BLUE BIRD

R11TA

## Starter Cable May Contact Power Steering Hose

**Models Affected: 2004 through 2006 Model Year "Vision"**

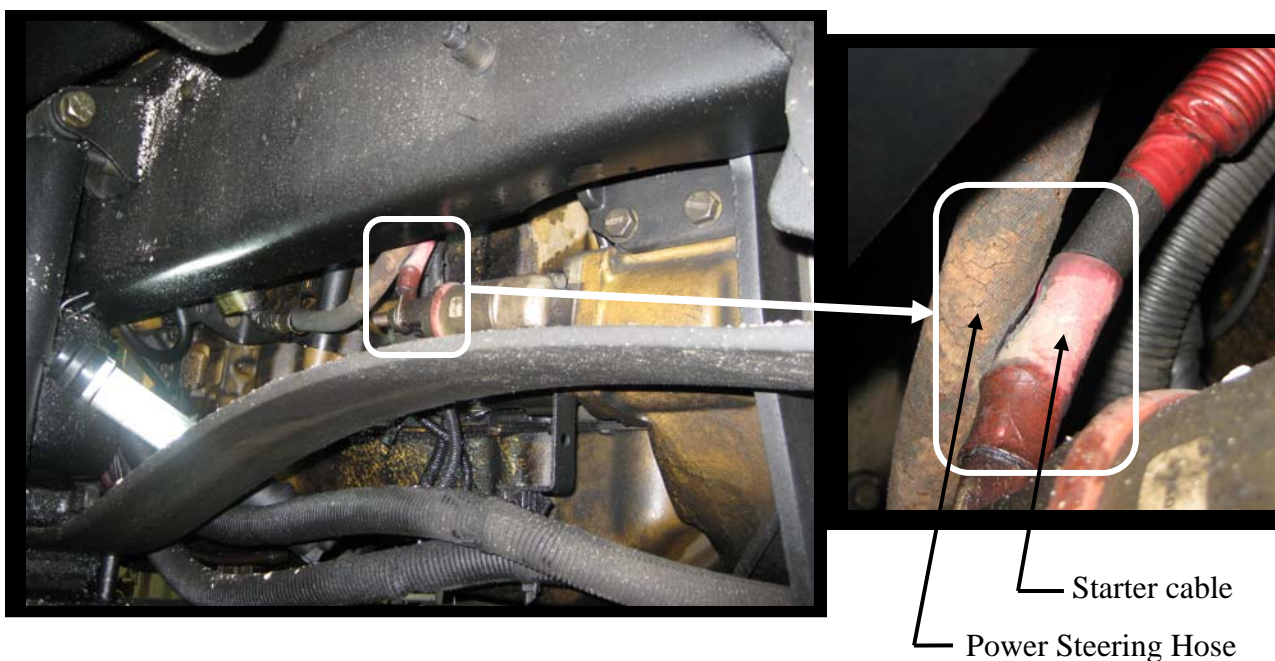
The starter cable may contact and potentially chafe against the steel braided power steering hose thereby creating a direct short which could result in a fire.

Inspect for proper clearance between the starter cable and the power steering hose. If insufficient clearance is found, install a clamp to prevent further contact. Any damaged power steering hoses or starter cables must be replaced.

1. Park the bus on a level surface, apply parking brake, and remove ignition key and chock wheels.
2. Disconnect Batteries: Note when disconnecting the batteries, remove the Negative cable first.
3. On lower left side (driver's) of engine; inspect the positive starter cable and power steering hose for possible contact as shown below.

Install dual swivel saddle mount and cable ties.

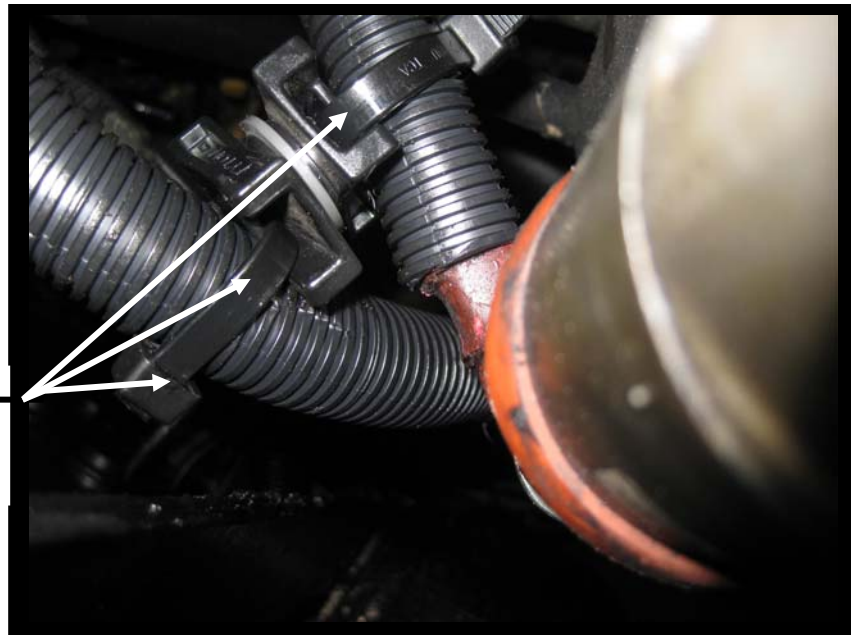
4. If the starter cable has contacted the power steering hose, separate and inspect both for any possible damage. If either has been damaged, contact Blue Bird Recall Administrator for a replacement.
5. If there is no contact and a minimum of one (1) inch clearance between the starter cable and power steering hose, no further action is required.
6. If there less than one (1) inch clearance, install a dual swivel saddle mount and two cables ties between the power steering hose and starter cable and secure with two cable ties.
